Recall Bulletin

SUBJECT: Rear Adjust Link Loose

MODELS: 2015 Chevrolet Corvette

4067115

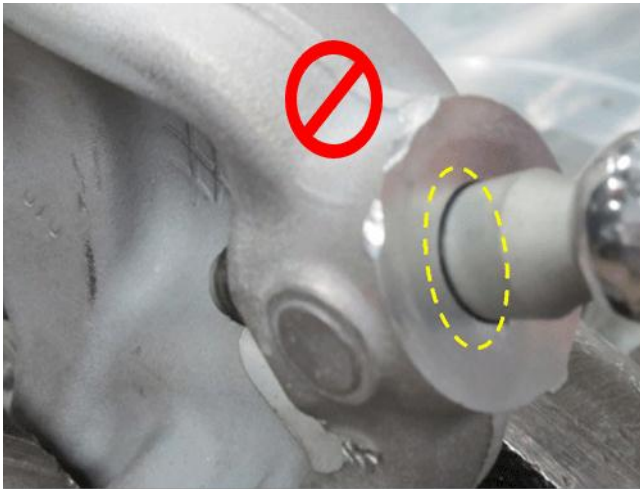
- 4.2 Loosen the adjust link nut (1) at the knuckle. The adjust link should separate from the knuckle.
- 4.3 Remove and discard the adjust link nut (1).

4067119

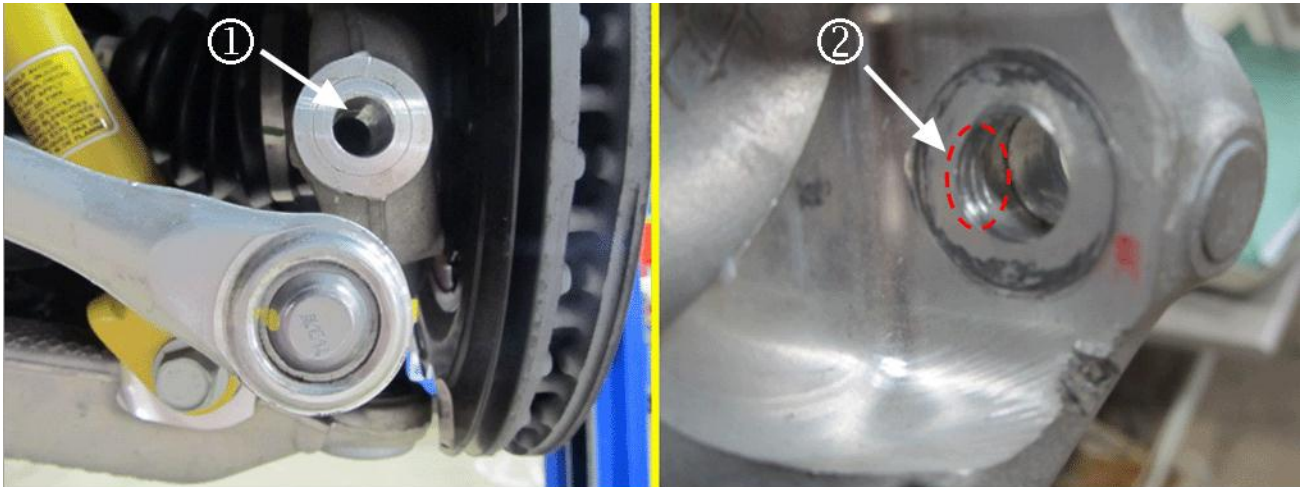
- 4.4 Visually inspect the round hole (1) in the knuckle, looking for evidence of oblong wear/damage (2).
 - If taper on the knuckle and ball stud shows NO evidence of damage (1), continue on to step #5 of this inspection procedure.
 - If taper on the knuckle or ball stud DOES show evidence of damage, it will be necessary to replace the link and knuckle. Proceed to *Adjust Link and Knuckle Replacement Procedure*.
5. Re-seat the ball stud.
6. Install the NEW adjust link nut (1) and tighten to:
 - First Pass, **30 N*m (22 lb ft)**
 - Final Pass, **plus 120 degrees**
7. Reinstall the tire and wheel assembly.
8. Lower and remove vehicle from hoist.

ADJUST LINK and KNUCKLE REPLACEMENT PROCEDURE

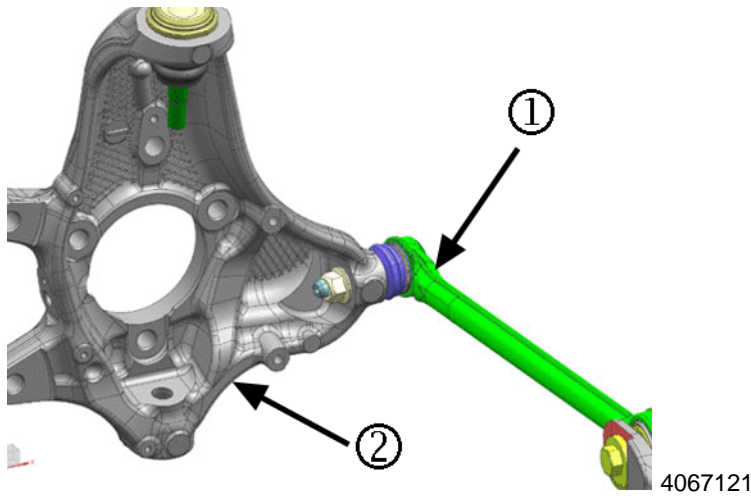
1. Remove the adjust link (1) and knuckle (2) from the vehicle. Refer to *Adjust Link Replacement* and the appropriate *Knuckle Replacement* procedure in SI.
2. Replace the adjust link and knuckle with new service parts. Refer to *Adjust Link Replacement* and the appropriate *Knuckle Replacement* procedure in SI.
